Modifications for the KENWOOD

created 28-03-2002 from www.mods.dk

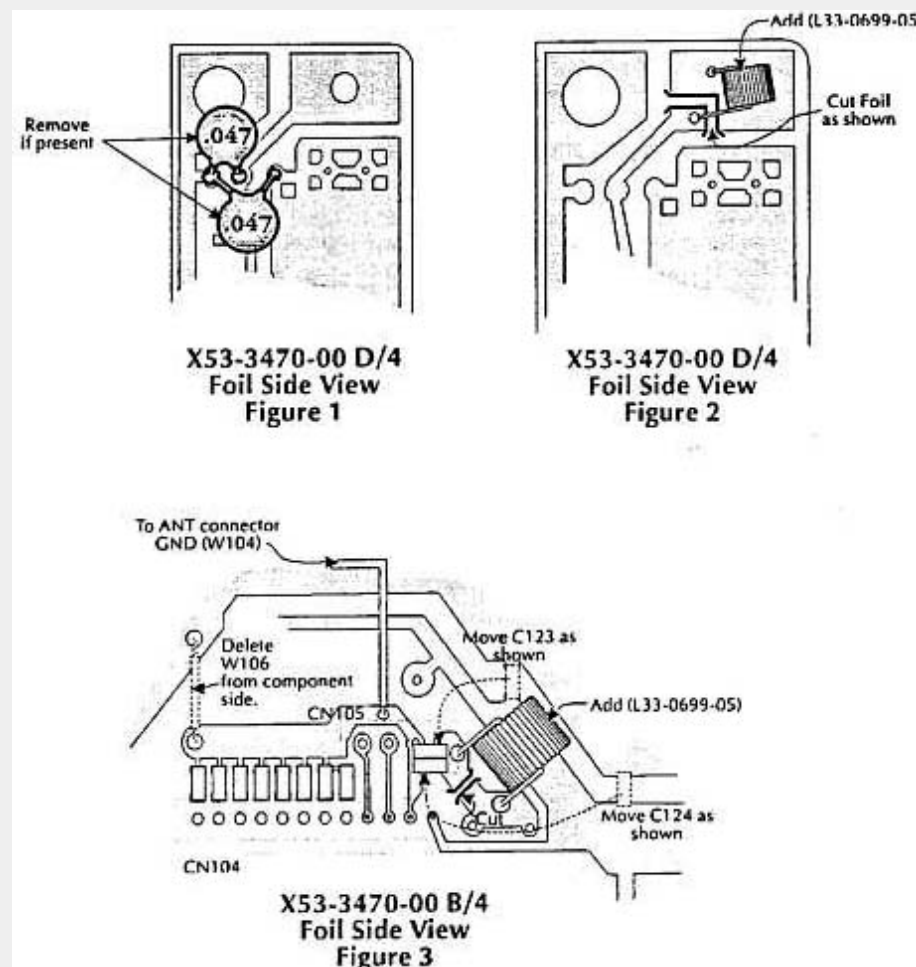
1. Remove the top and bottom covers from the antenna tuner.
2. Locate X53-3470-00 D/4 (it is attached to the top left side of the chassis with the foil side up).
3. Remove the two .047 μ F capacitors shown in figure 1 if they are present.
4. Cut the foil and add one of the toroidal inductors as shown in figure 2.
5. Turn the tuner over and locate capacitor C123 and C124, as shown in figure 3.
6. Move the capacitors (or add new capacitors) to the locations shown in figure 3.
7. Cut the foil path and add the remaining toroidal inductor as shown in figure 3.
8. Remove jumper W106 as shown in figure 3. (Note: remove the jumper from the component side of the board).
9. Add a jumper from the ATG foil to W104 as shown in figure 3.
10. Replace the top and bottom covers.

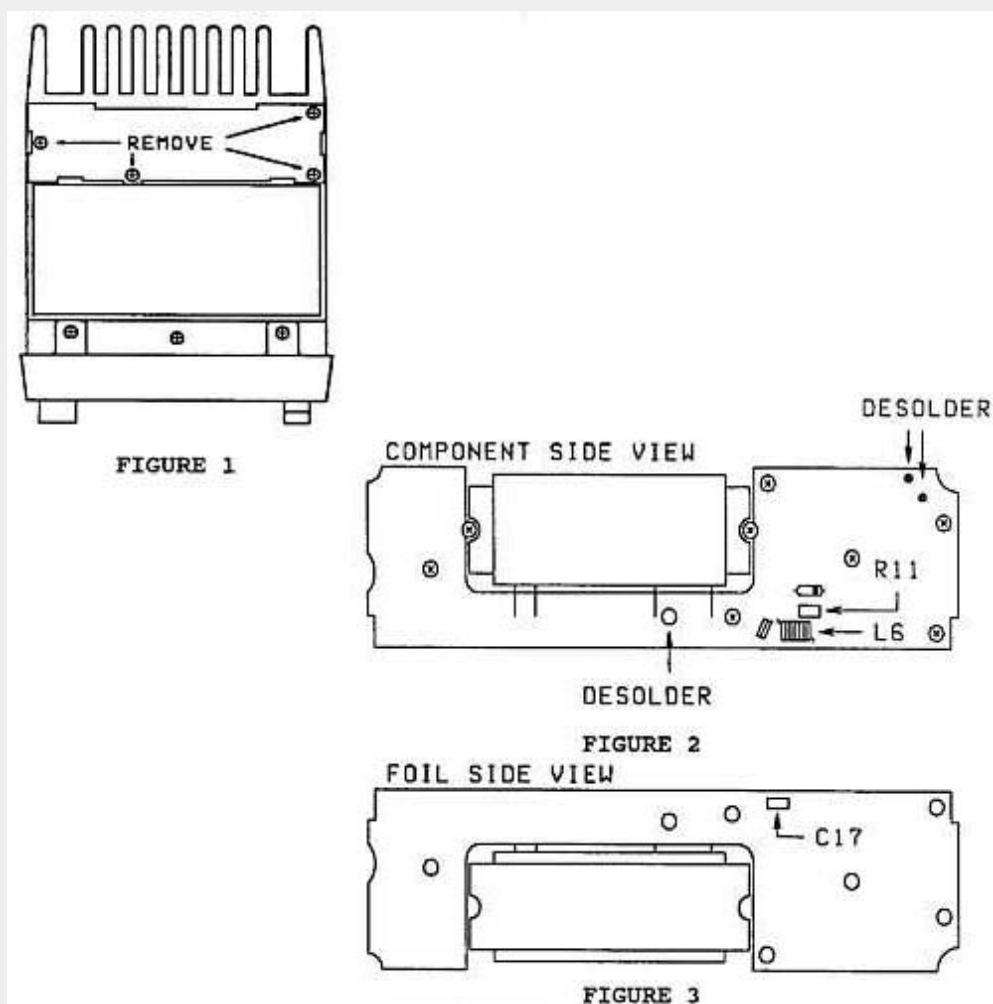
Bypass capacitor C17 on the 144 MHz Final board has been changed in production from a "flat package" chip capacitor to a "cylindrical package". The change prevents the capacitor from fracturing. If C17 fractures, the output of the power module can burn C17, R11, and L6. Additionally, Q1 on the TX/RX 144 MHz board may be damaged.

C17 should be changed as a part of routine maintenance when a TM-731A/631A is received for service. The new style capacitor part number is CK41FY1E102M. For field service, a 0.001 μ F, 25 V disc ceramic capacitor can be used.

The transmitter hang time can be toggled between 500ms to 0ms by turning on the radio with [LOW] pressed. They also recommend enabling the Time-out Timer, for obvious reasons.

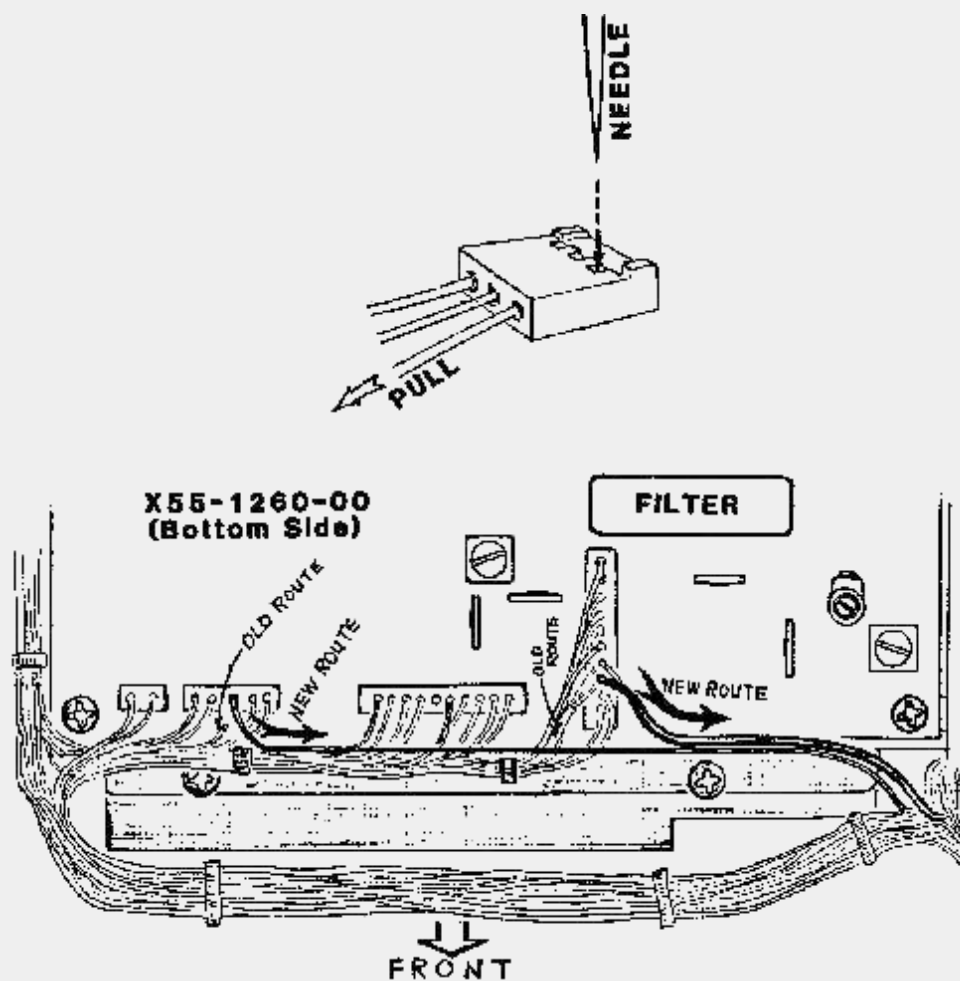
For example, if you can receive a distant repeater with your HT, but have difficulty getting into it, you can use the TM-733 to boost your transmitted signal. To set this up, just omit the part where you "change the control to the other band by pressing [CONT SEL]." Doing this will setup the TM-733 to repeat your signal to the other band, but will not retransmit the distant station back to you. If this sounds ambiguous, play around with it a little and it will begin to make sense.

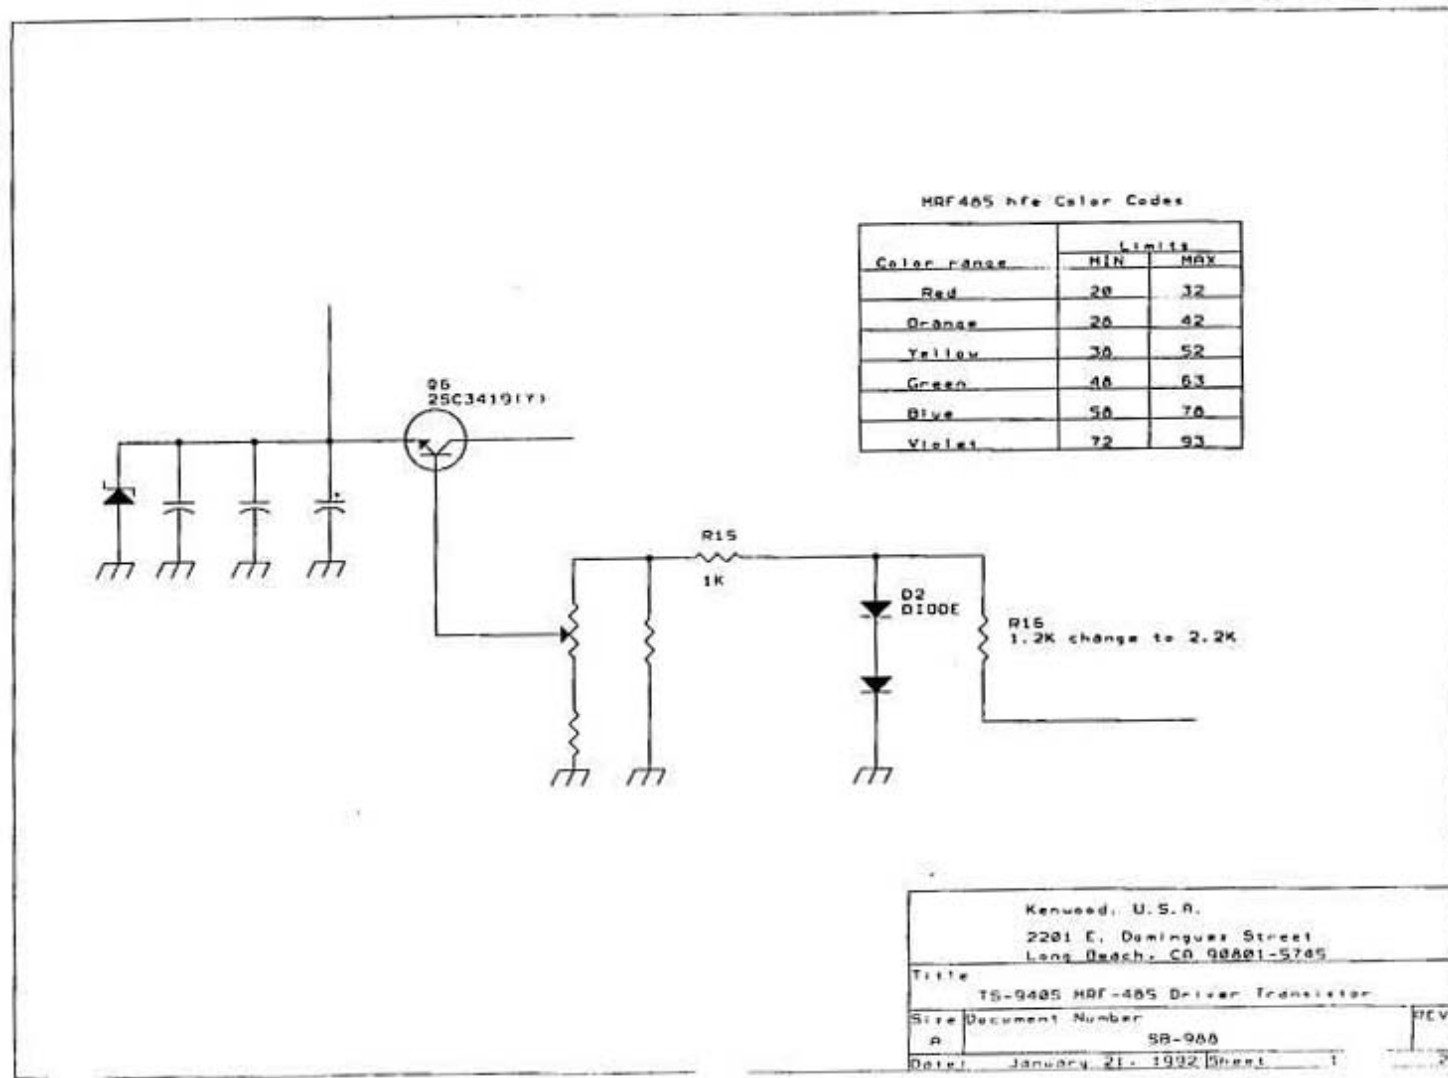
Serial number lot	Varistor	R15	R16	MRF485 Green or Higher rank
106xxxx or earlier	STV3H(O)	820	1.2 K	See "Caution below"
107xxxx or later	SV03YS	1 K	2.2 K	Change R16 from 1.2 to 2.2 K

Caution: If using a Green or higher hfe rank one of the above countermeasure must be taken depending upon the serial number of the set. After replacing the drivers check the bias current. We recommend transmitting for 1 hour in SBB mode with no modulation into a dummy load. After this time frame check the bias current. It must not exceed 300 mA on the original radio. If the current changes you must change R16 from 1.2 Kohm to 2.2 Kohm.

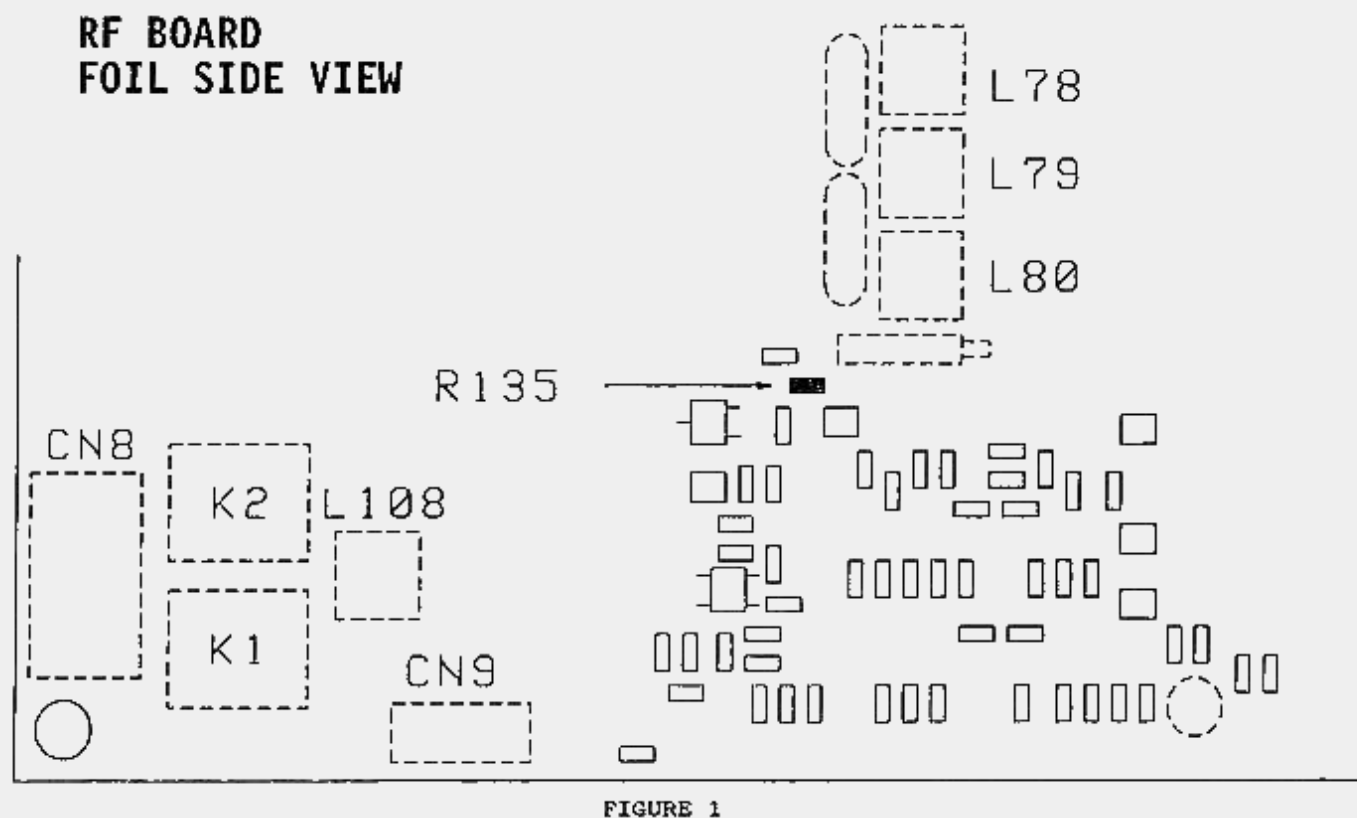
When the MONI switch is turned on, transmit power may not develop for two seconds after key down. During this time, the ALC meter will pin and the SWR meter will read high. This will more likely develop on 18 MHz and 21 MHz bands. The following modification will correct this condition.

Note: This modification has already been performed on model from serial number 0120441.

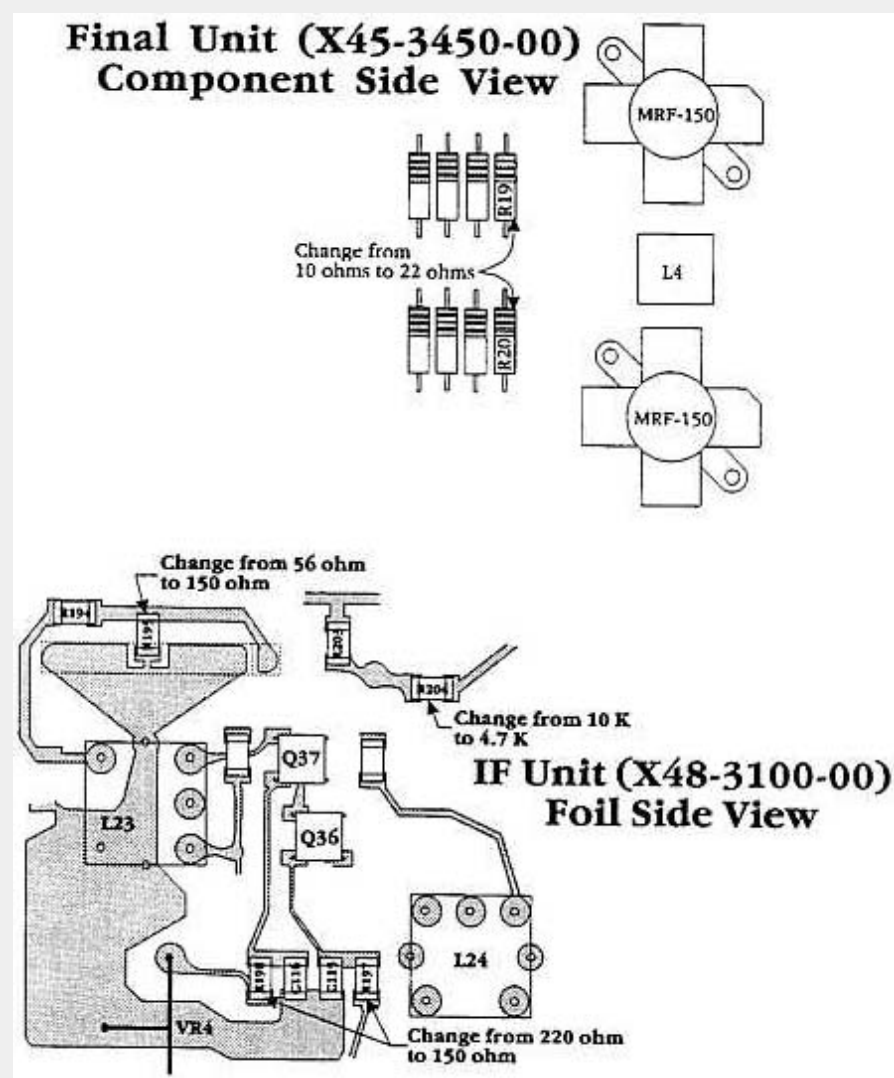
1. On the Final unit (X54-3450-00) change R19 and R20 from 10 ohm to 22 ohm. Figure 1.
2. On the IF unit (X48-3100-00): Figure 2.
 - a. Change R195 from 56 ohm to 150 ohm.
 - b. Change R197 from 220 ohm to 150 ohm.
 - c. Change R198 from 220 ohm to 150 ohm.
 - d. Change R204 from 10 Kohm to 4.7 Kohm.
